*The Ipswich Road and Harwich Road  
roundabouts, Colchester*

*A Formal Complaint to Essex County Council*

*By Will Bramhill, a member of Cycling UK and Colchester Cycling Campaign*

*January 15, 2018*

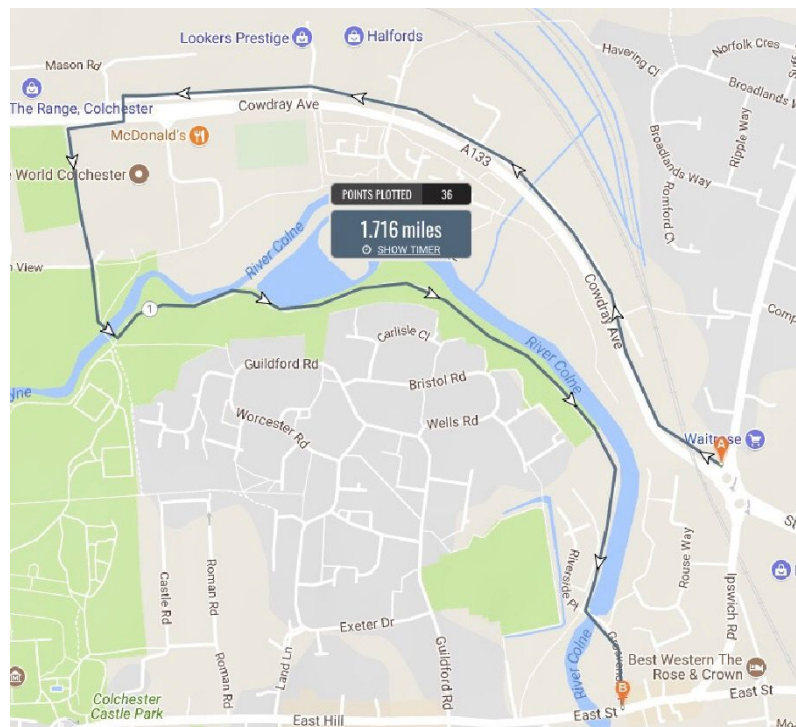
Figure 2.1.2 shows a similar situation to the Ipswich Road/Harwich Road project, highlighting how a 4-minute cycle journey is preferred to an 8-minute cycle journey. At 2.4.1 the note touches on the need for cyclists avoiding junctions that are too busy. It mentions the provision of “alternative routes to enable cycle traffic to avoid junctions, although such routes shall not add significant additional delay or distance, otherwise cyclists may not use them.”

*Cyclists face a diversion of 1.7 miles because ECC has not catered for cyclists at the Ipswich Road roundabout.*
